A47 North Tuddenham to Easton Dualling

9.29 Applicant's Written Summary of Oral Submissions at ISH3

**APPLICANT'S WRITTEN SUMMARY OF ORAL SUBMISSIONS
AT ISH3**

Regulation Number:	Rule 8(1)(c)
Planning Inspectorate Scheme Reference	TR010038
Application Document Reference	TR010038/EXAM/9.29
Author:	A47 North Tuddenham to Easton Project Team, Highways England

SECTION C - 'C' OVERVIEW
SCALE 1 : NTS

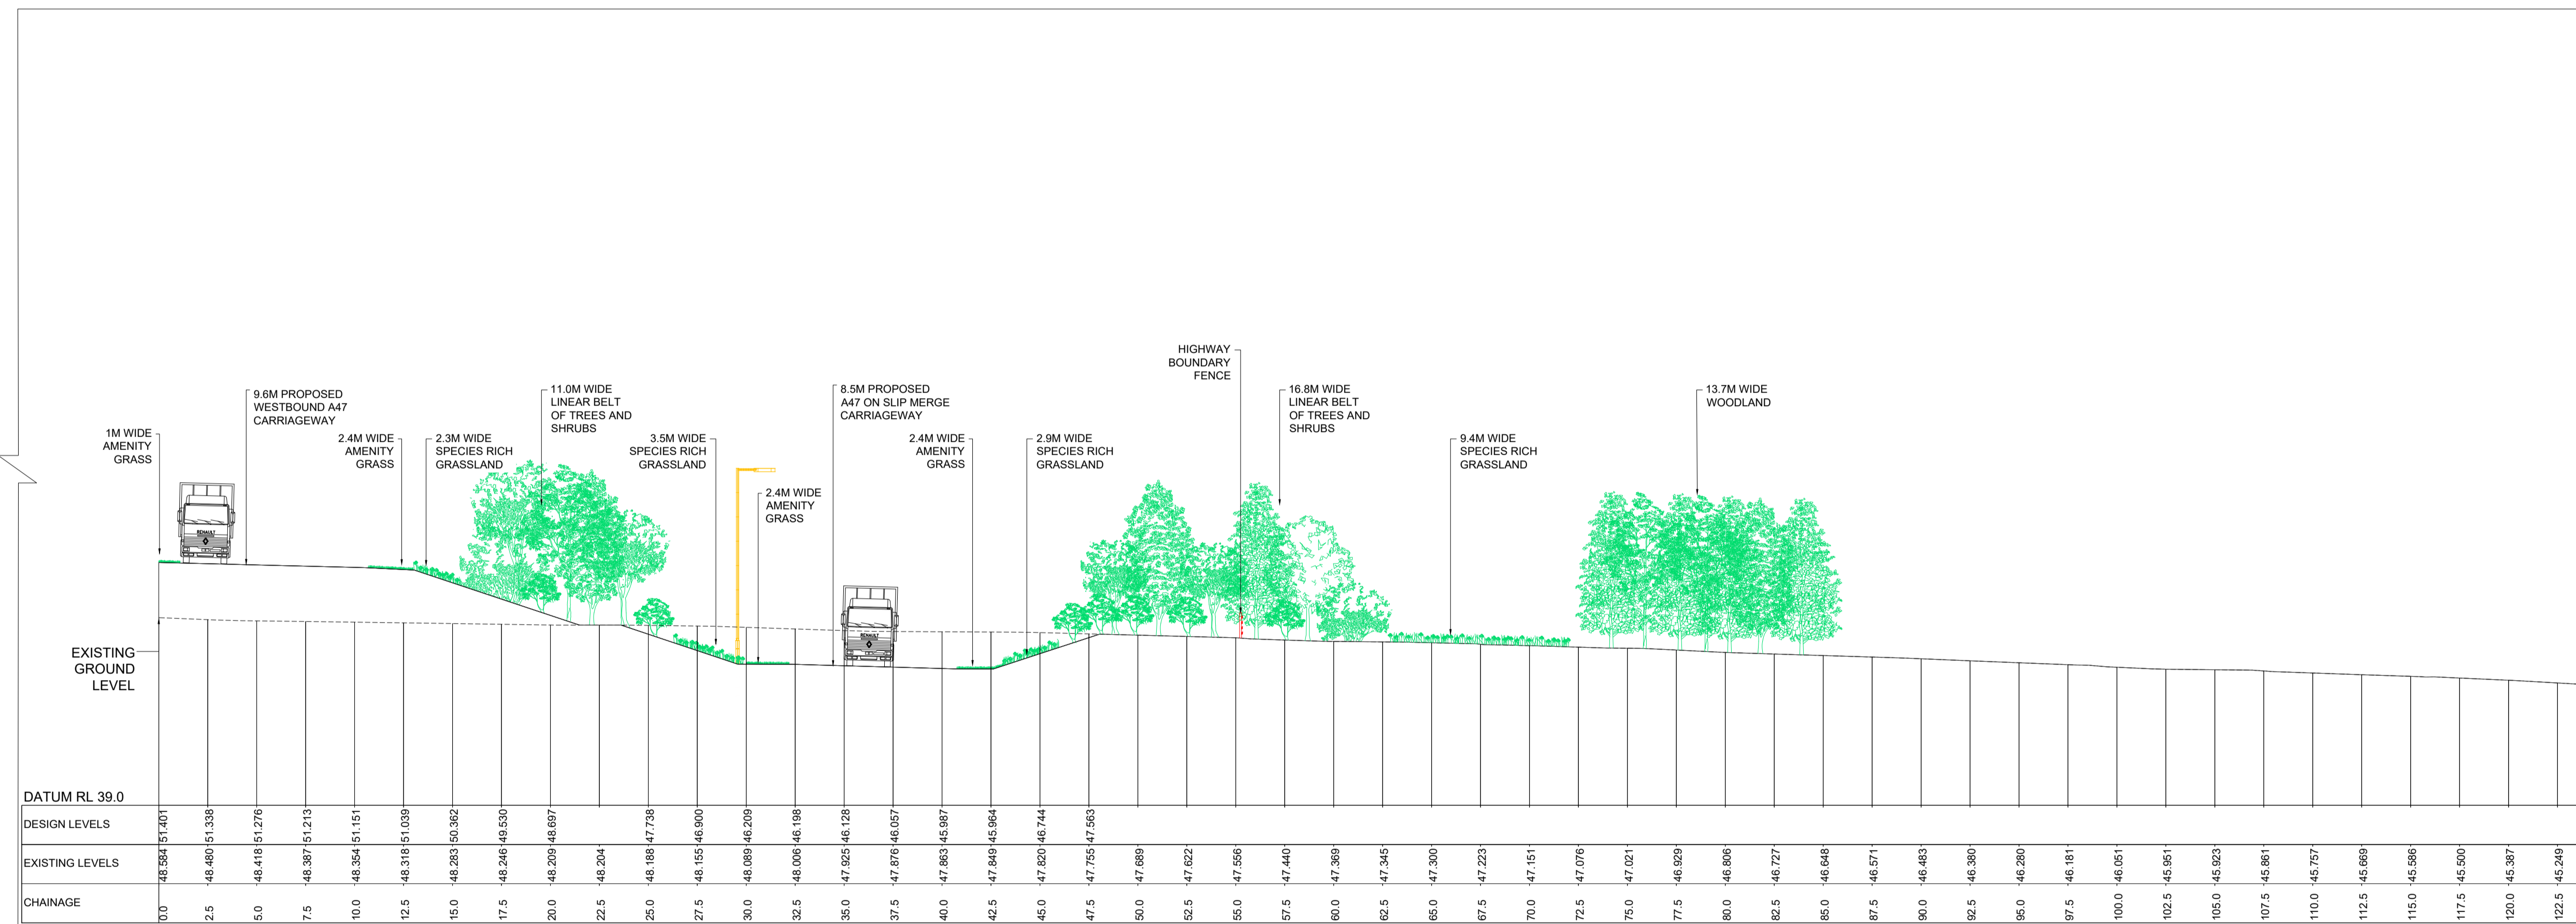
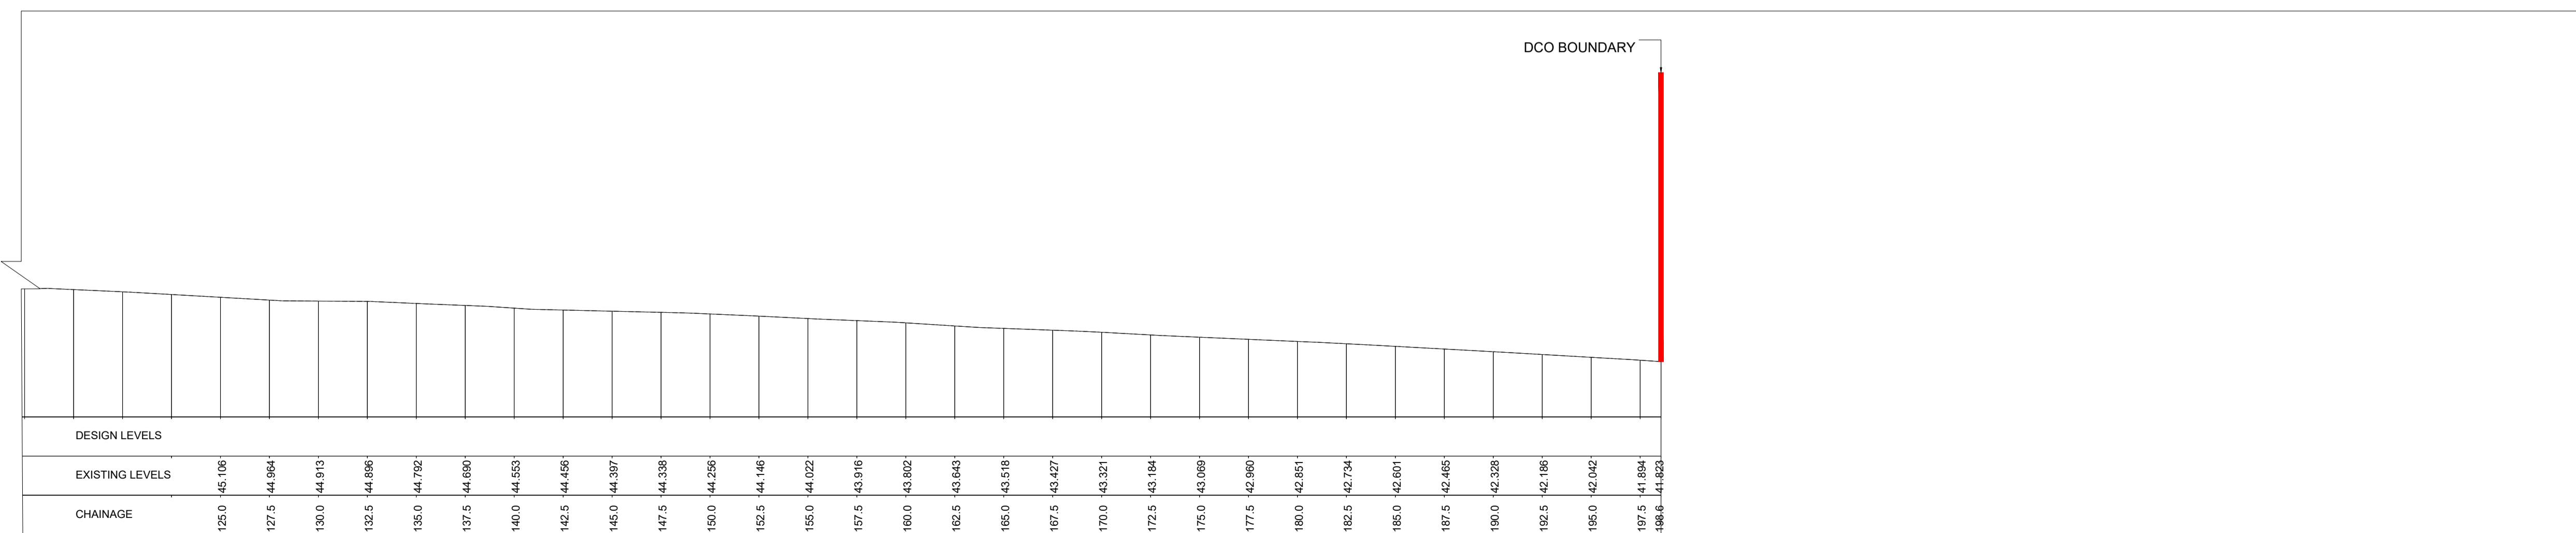
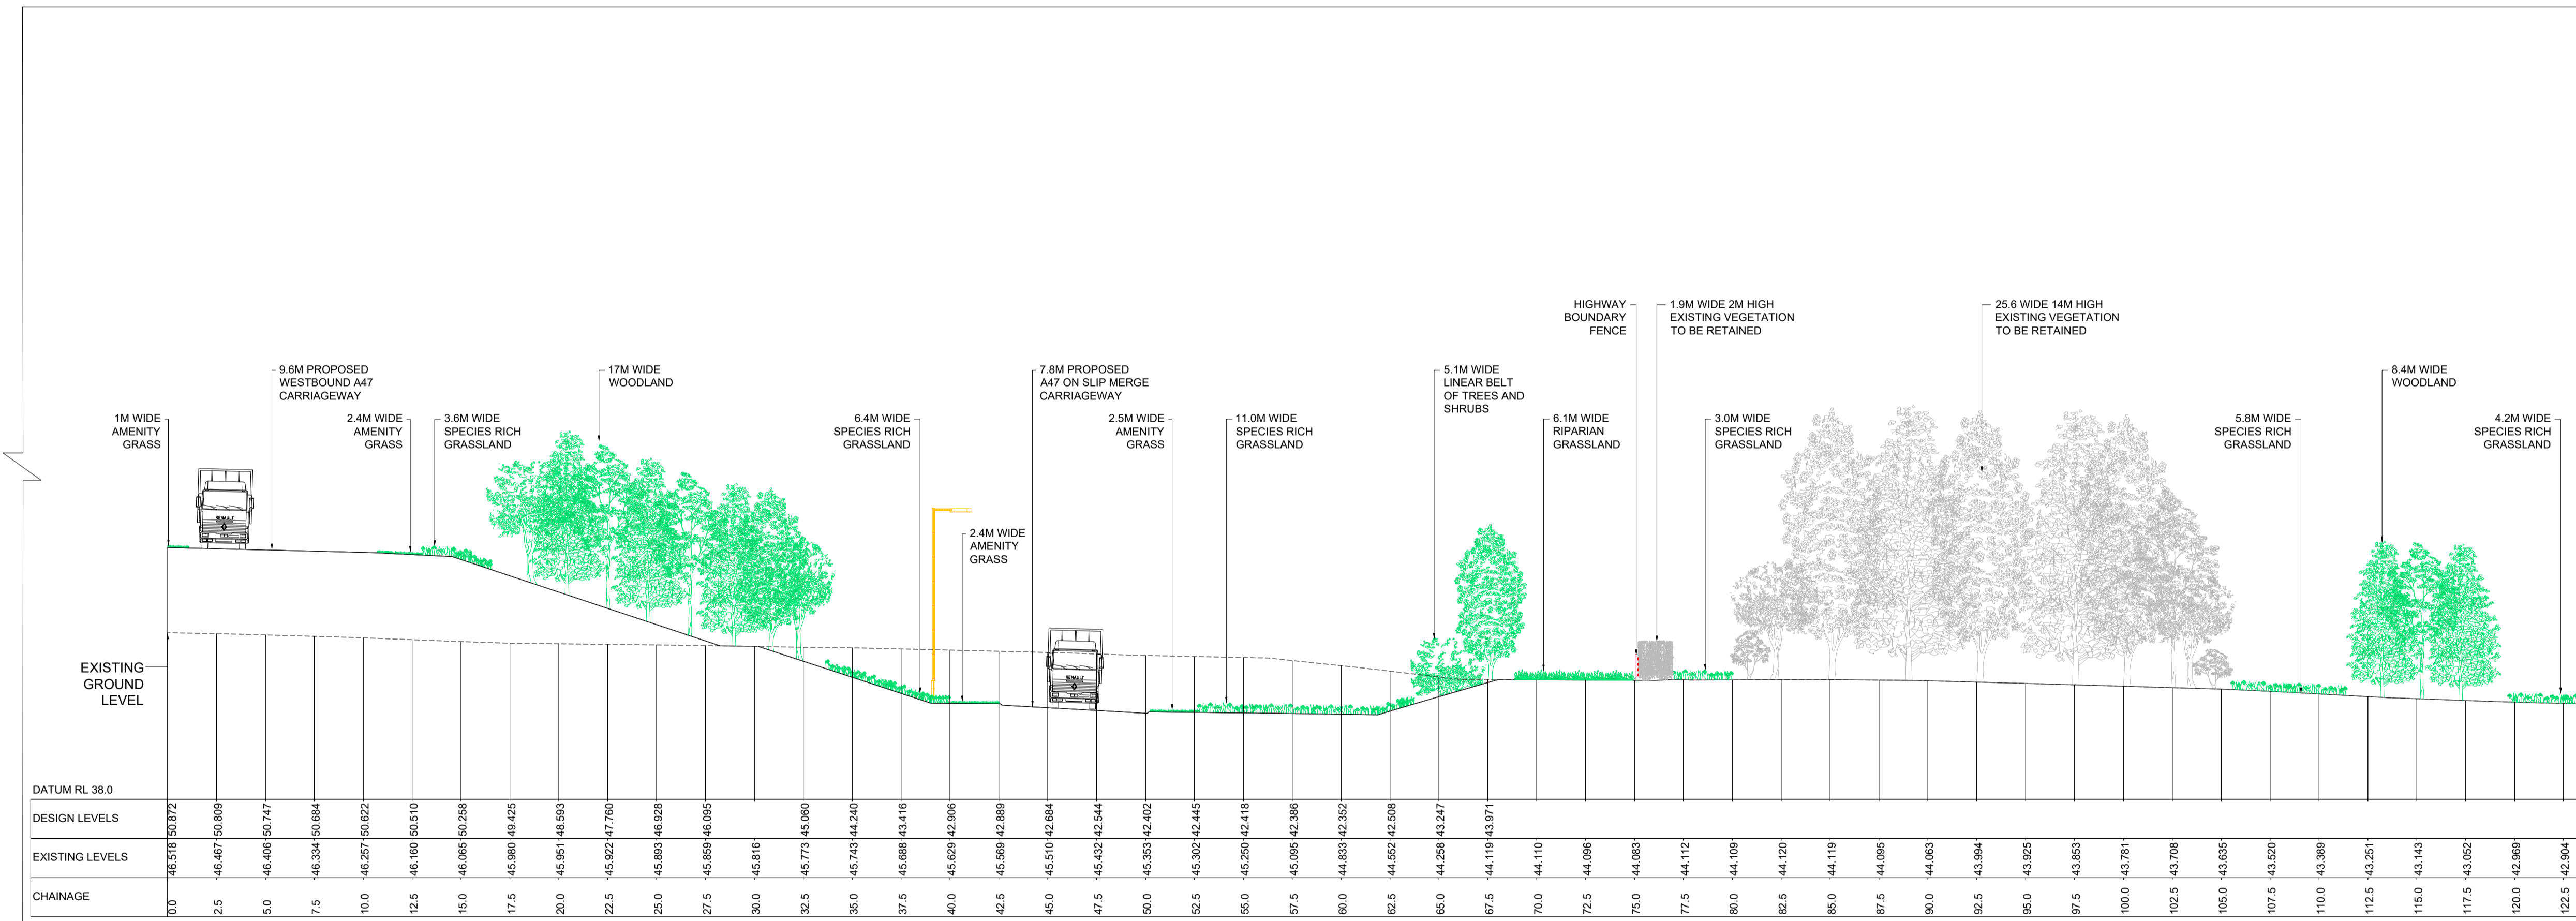
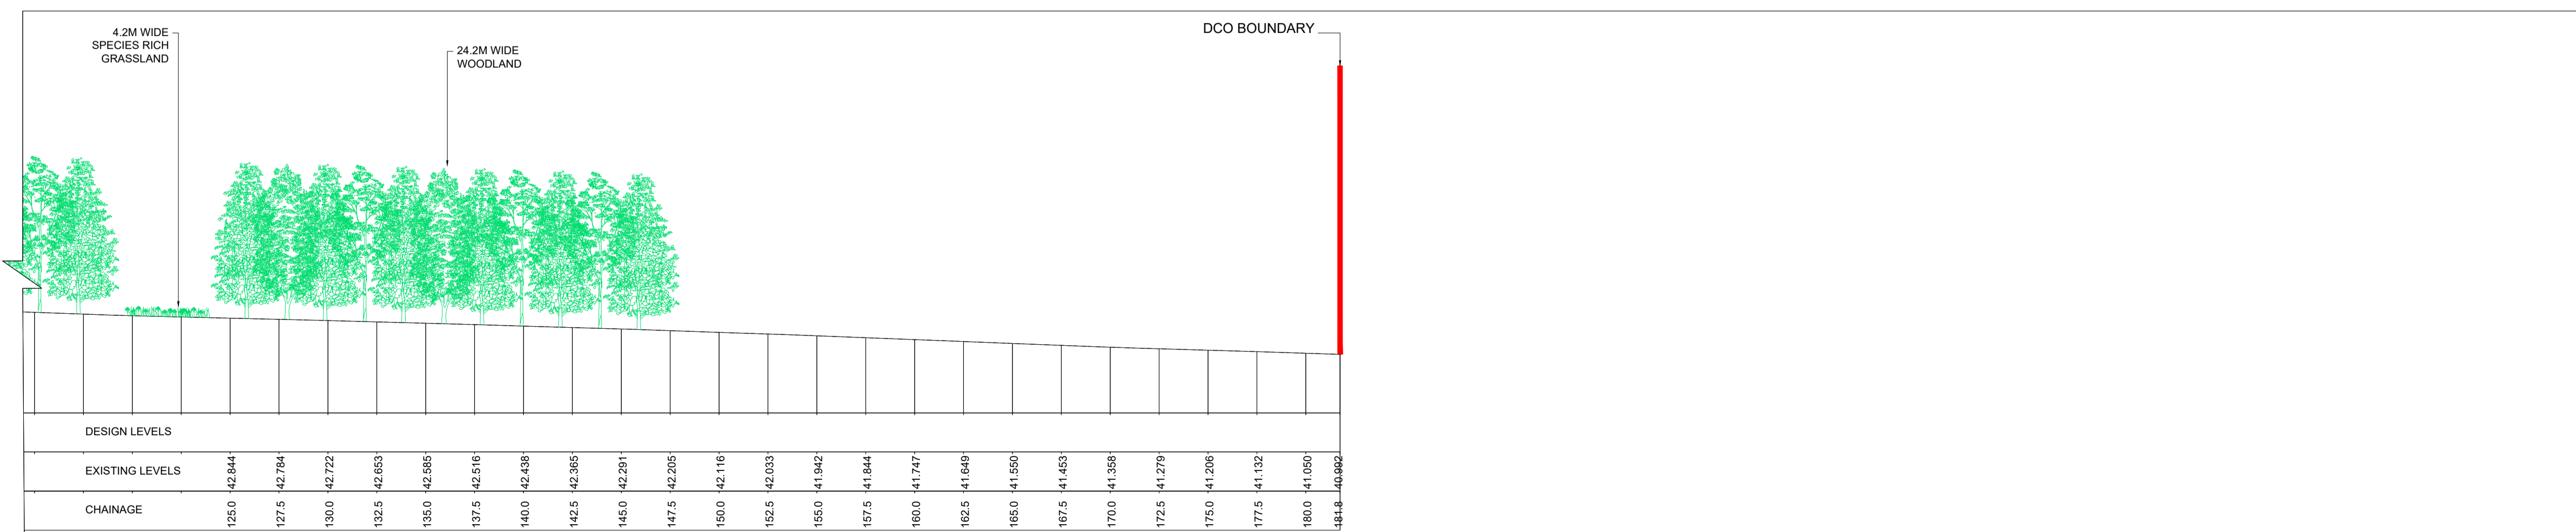
41.	<p>The ExA highlighted a question raised in a previous ISH in relation to the methodology used for cross-sectional drawings.</p> <p>The ExA also queried whether any lighting columns are shown on the cross-sections.</p> <p>George Josselyn asked if it would be possible to delineate the existing trees with those proposed by a change in the colouring and if a line could be drawn showing the limit of the permanent acquisition of land on the cross-section.</p>	<p>The Applicant stated that it would respond in writing to this question with a brief methodology on the preparation of the cross-sections Mr Josselyn referred to.</p> <p>The cross-sections were produced in line with the latest information and data, including topographic data, arboricultural data and the arboricultural masterplan (REP3-016) and are intended to show the scheme planting at a reasonable level of maturity. The existing (retained) trees are shown using data from the arboricultural assessment which makes the retained trees as accurate as possible on the sections.</p> <p>In relation to the lighting columns the Applicant stated that there are no lighting columns that directly dissect the section lines but that the Applicant will include indicative columns within areas to be lit to indicatively illustrate their relative scale and location.</p> <p>In relation to the cross-section drawings the Applicant highlighted that the limit of permanent acquisition is shown by reference to the Highway Boundary Fence. Existing vegetation has also already been annotated on the plans.</p>	<p>Appendix A of this ISH3 hearing note contains updates to the cross-section drawings submitted as Appendix A to the 'Applicant's Response to the Examining Authority's Third Written Questions' (REP6-018). The approach to producing the cross-sections was as follows:</p> <ul style="list-style-type: none"> • The location of the sections was selected to give a range of illustrative material within the vicinity of the proposed junctions and based on a request from the landowners agent for sections at chainages through the road centreline and southwards into Berry Hall Estate. The Applicant reviewed the chainages and provided sections as required including an additional section (Section F-F) not requested by the landowner. • The sections were produced using the Scheme design submitted for Examination, existing topographical survey data and exported from the 3D modelling software.

Ref	Questions / Issues Raised at ISH3 and Hearing Action Points	Summary of Applicant's Response at ISH3	Applicant's Written Response
		<p>The applicant will update the visual representation of existing/proposed vegetation and the freehold boundary in a re-issue of the sections.</p>	<ul style="list-style-type: none"> • The retained existing tree cover is illustrated as accurately as possible, utilising project arboricultural information (refer to APP-094, Appendix 7.6). The height of retained existing trees is represented utilising surveyed heights from the arboricultural report, but does not account for future growth post that survey. • As part of the Scheme, the following key components are also shown: <ul style="list-style-type: none"> - Proposed mitigation planting. Planting information is taken from the Environmental Masterplan (AS-007) and is shown at 8m above proposed ground level, therefore linking to Table 7-6 of EIA Chapter 7 (APP-046) which defines planting heights at Year 15 of operation of the Scheme. - The proposed highway boundary is shown by inclusion of the "Highway Boundary Fence". - Indicative locations of lighting columns are shown at 10m in height, as assessed in the EIA. - Vehicles on the Scheme are shown at a maximum of 4m in height (above road level), the tallest vehicles being lorries.
